SUBJECT: FY15 Joint Routine Inspection of Completed Works, Flood Damage Reduction Project, Genesee River and Dyke Creek, Wellsville, New York (09/10/15)

Subject: FY15 Joint Routine Inspection of Completed Works, Flood Damage Reduction Project,
Genesee River and Dyke Creek, Wellsville, New York (09/10/15)

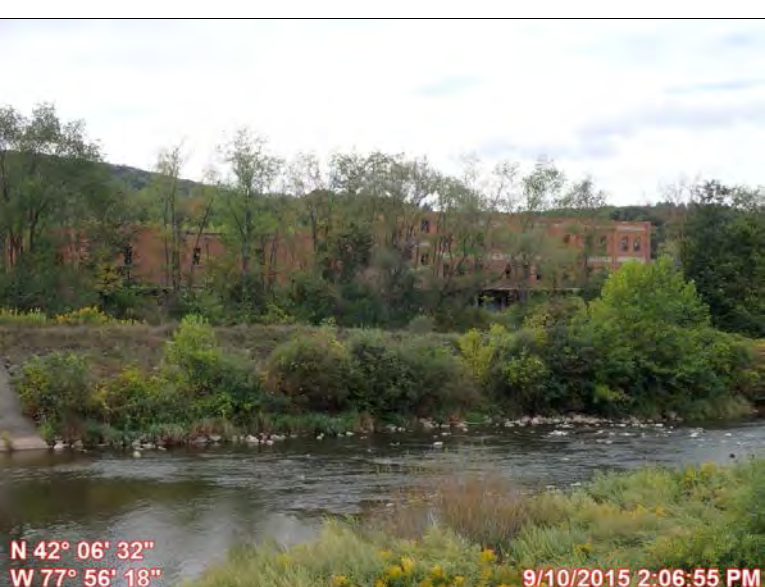
<p>N 42° 07' 04" W 77° 56' 49" 9/10/2015 12:47:41 PM</p>	<p>Inspect ID: N21L_2015_a_0085 Title: USACE_CELRB_N21L_2015_a_0085_1.jpg Rated Item: 1. Unwanted Vegetation Growth Caption: Rating: Minimally Acceptable; Remarks: Unwanted vegetation and bushes on landside slope and within 15' of landside toe 500' upstream of State Street bridge.; Action: Remove unwanted vegetation.; Station_1: 28+00</p>
 <p>N 42° 06' 59" W 77° 56' 50" 9/10/2015 12:54:52 PM</p>	<p>Inspect ID: N21L_2015_a_0089 Title: USACE_CELRB_N21L_2015_a_0089_1.jpg Rated Item: 1. Unwanted Vegetation Growth Caption: Rating: Unacceptable; Remarks: Significant unwanted vegetation in left bank riprap from 400' to 700' upstream of Steel Sheet Pile Weir.; Action: Remove vegetation from riprap.; Station_1: 21+00; Station_2: 24+00</p>
